**ADDENDUM No. 1 TO ORIGINAL INVITATION TO BID**

**Bid No.: 5462-2017 James S. Rickards High School Auditorium Theatrical Controls Replacement**

**Leon County Schools  
Rickards High School  
Building 20 Auditorium Theatrical Lighting Controls Replacement**

Addendum One  
4/17/2017

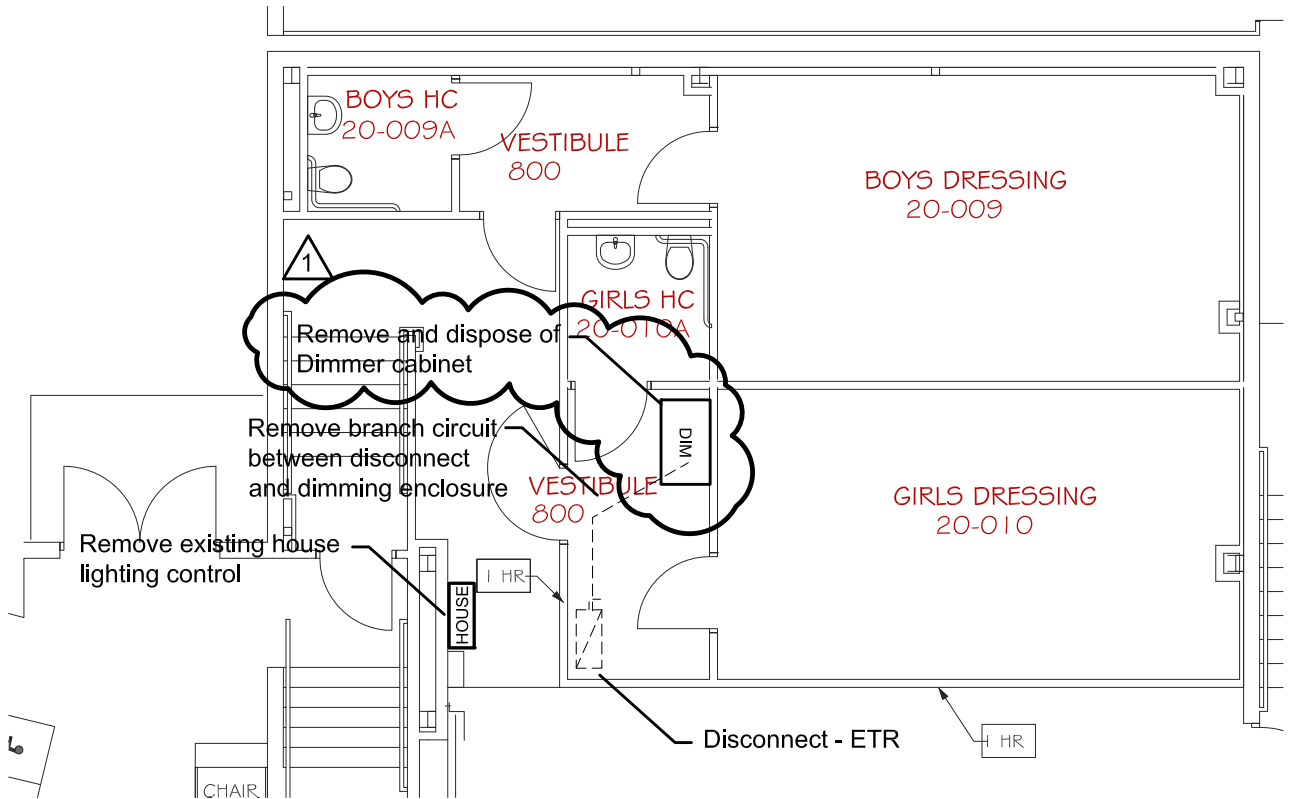
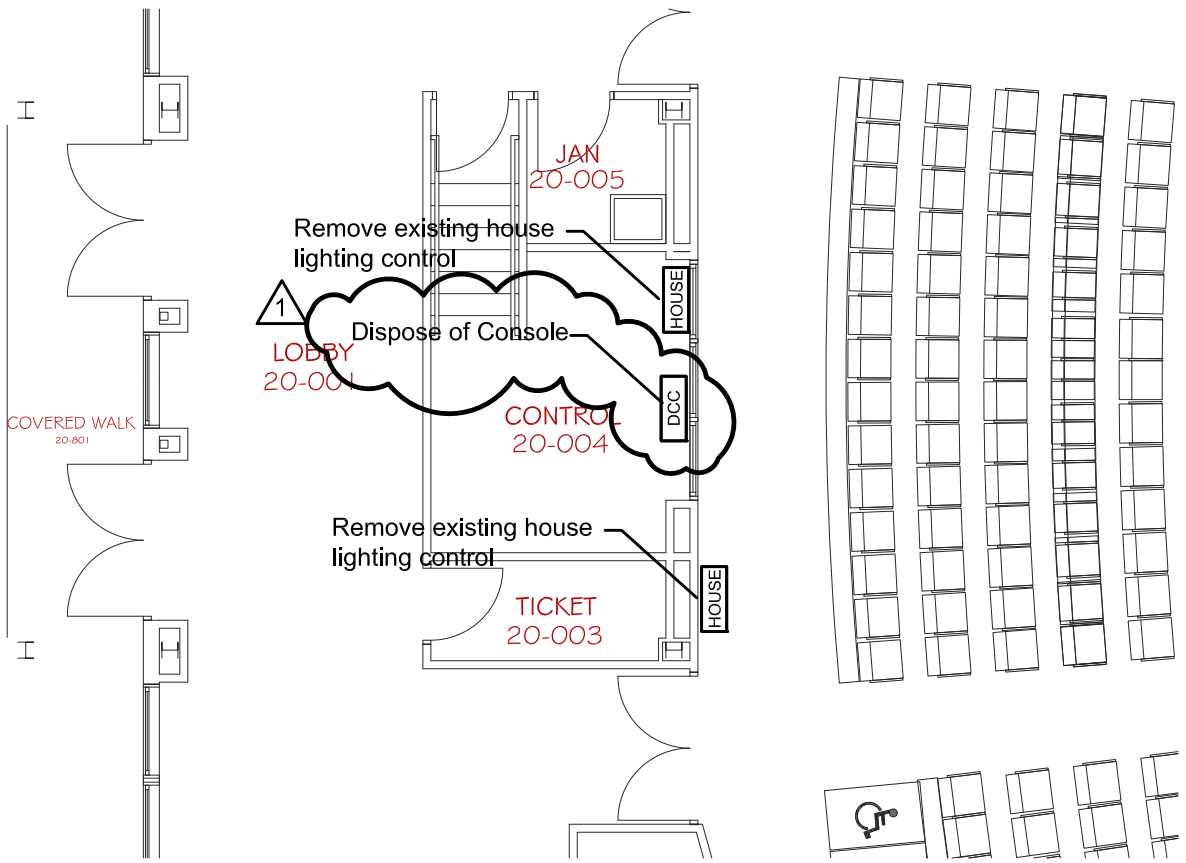
Add SK-1/E2.1, SK-2/E2.1 – Refer to attached sketches. Contractor to remove and dispose of existing dimming console and dimming cabinet. This equipment shall be disposed of offsite and at an appropriate electronics handling facility.

1. Materials to be turned over to the Owner or disposed of in accordance with general notes.
2. Remove all control cables.
3. Oversize backboxes (for multi slider controls) may be reused for pushbutton control stations. Provide finished coverplate, painted black, with suitable openings for new stations.
4. Work on energized equipment is not allowed under any circumstances.

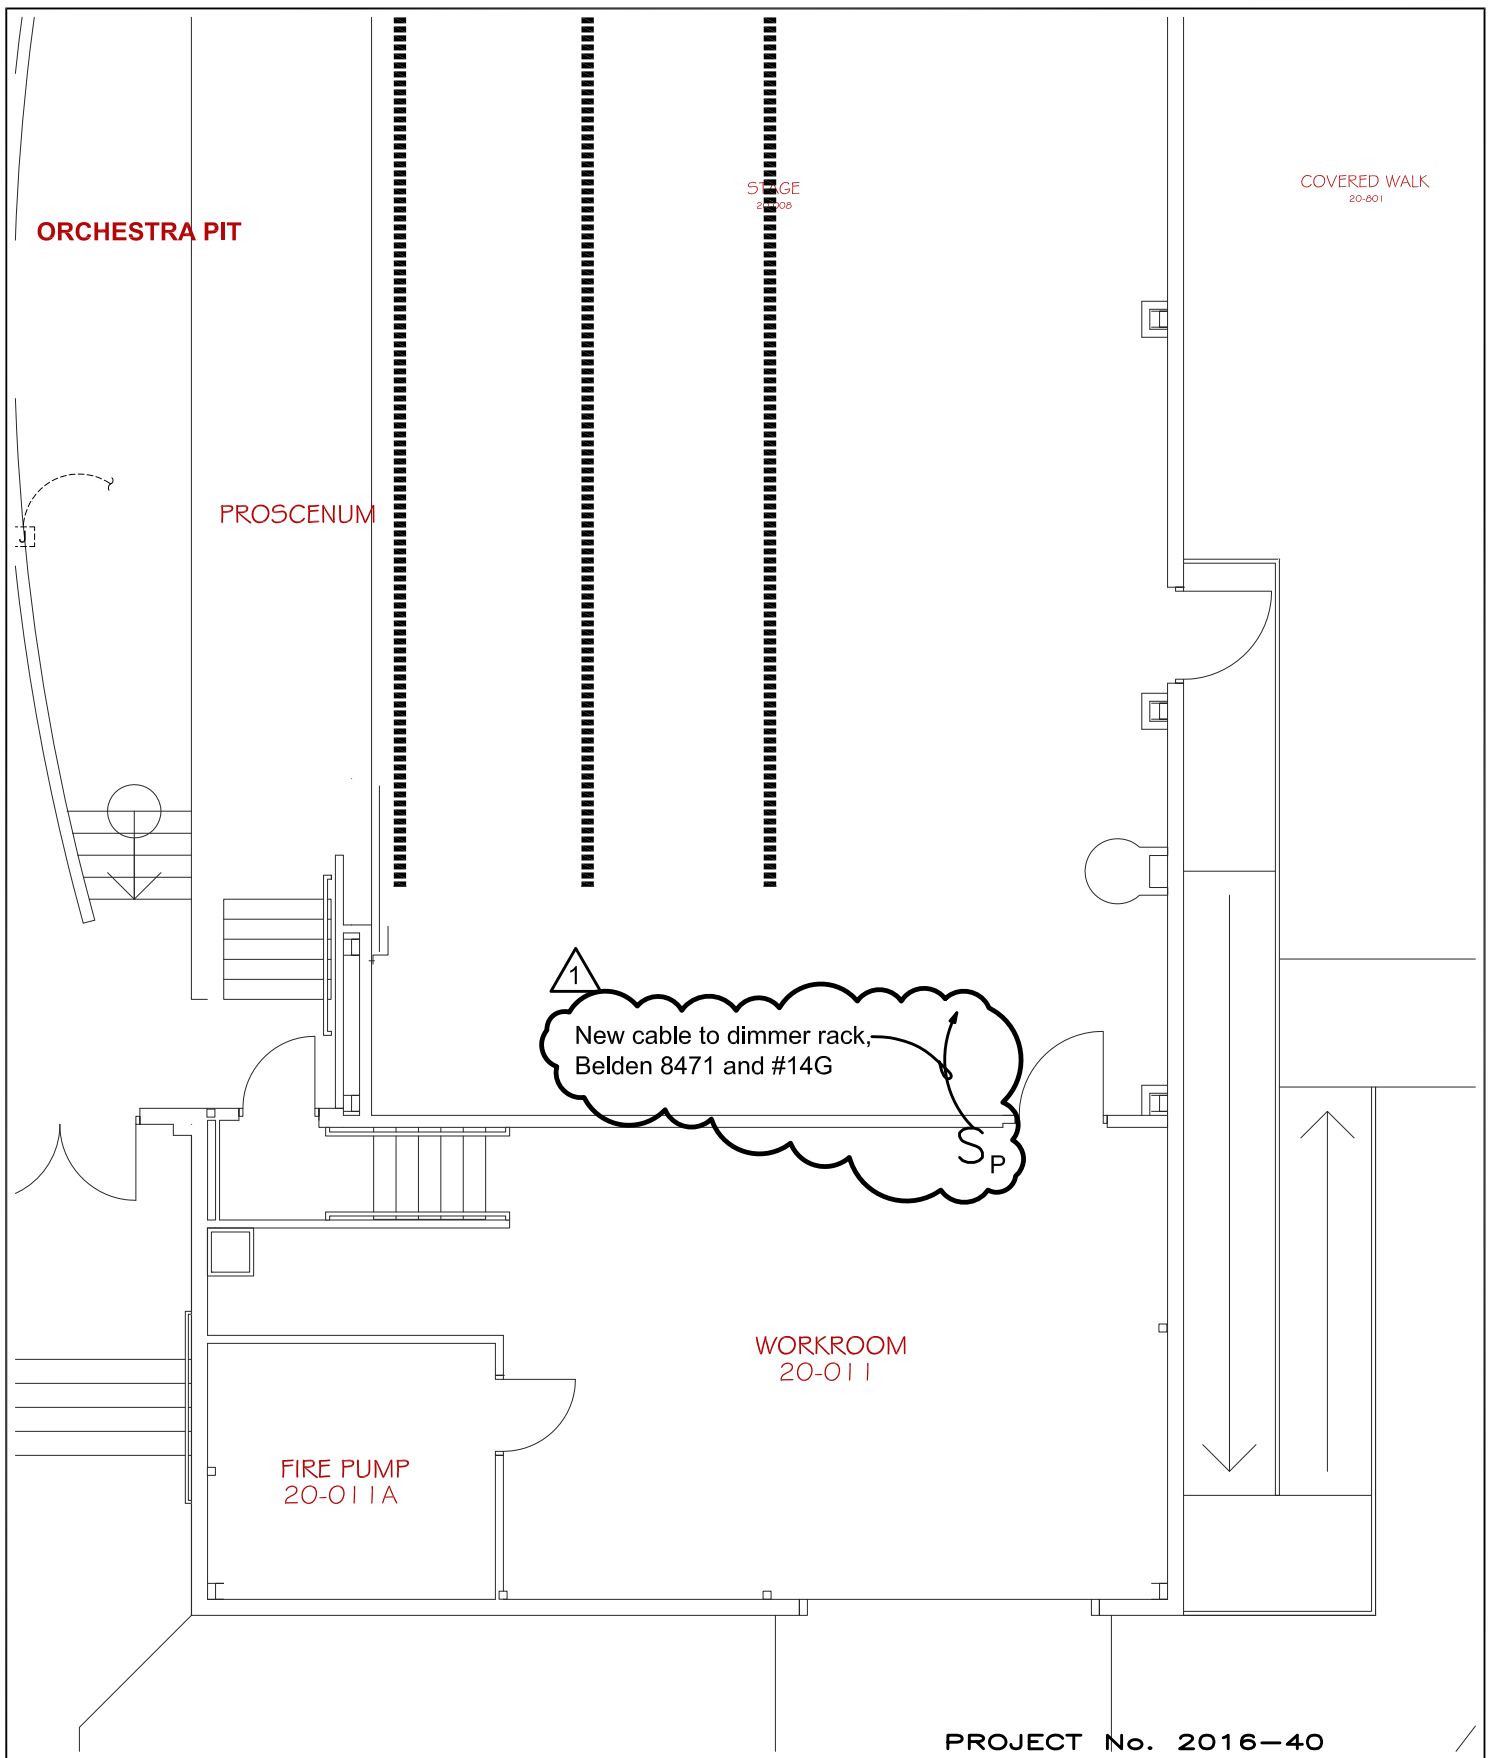
Add SK-3/E3.1, SK-4/E3.1, SK-5/E3.1, SK-6/E3.1 – Delete preset control stations with slide dimmer capability. All preset stations to be 4 button type. Control cables to preset stations shall be Belden #8471. Refer to attached sketch showing revised Scope of Work notes. DMX outlets located adjacent to gridiron junction boxes shall be single, output types for DMX cable connection to connector strips. Note this cable connection (jumper) is custom length and lashed to power cable. Contractor to field verify lengths.

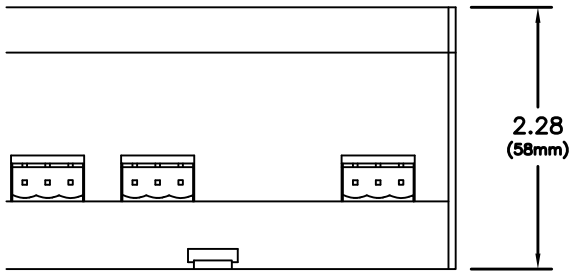
3. Three scene pre-programmed control station shall be programmed for assembly or general use. Furnish and install the four (4) new control stations in the locations shown to provide 4-button preset controls to house lighting. Channels shall be selected by Owner.

8. Provide painted trims and covers for a first rate installation where larger control stations are replaced with small; back boxes may be reused.

SKETCH No. SK-7/E4.1

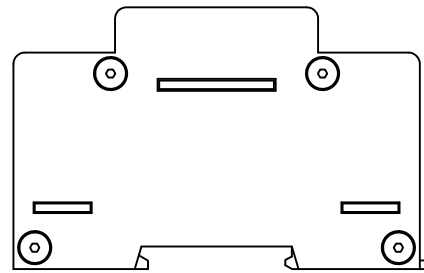
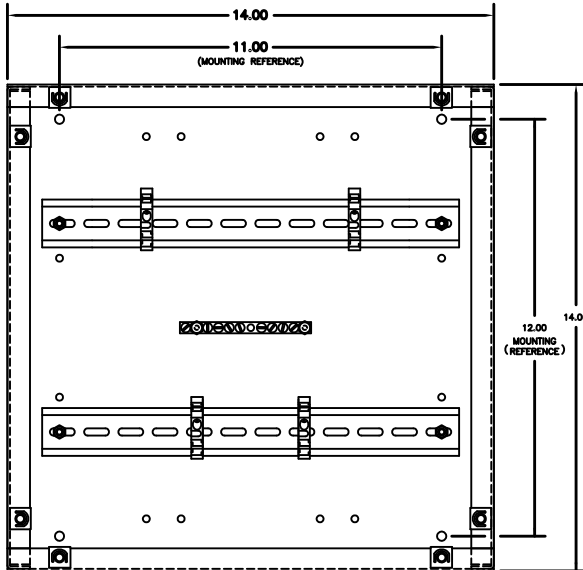
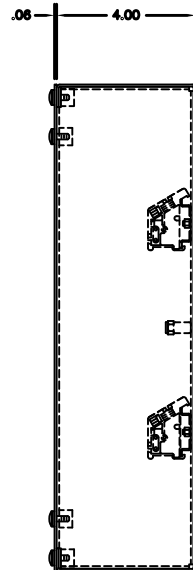
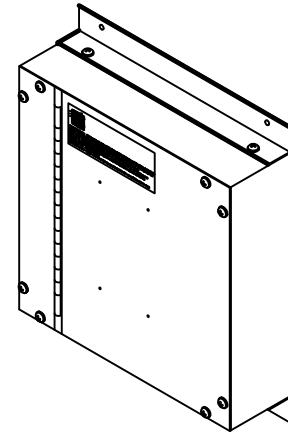
Add SK-7/E4.1, SK-8/E4.1, SK-9/E4.1 – Provide factory, wall mountable enclosure for DMX splitter assembly. Delete preset control stations with slide dimmer capability. All preset stations to be 4 button type. Control cables to preset stations shall be Belden #8471.
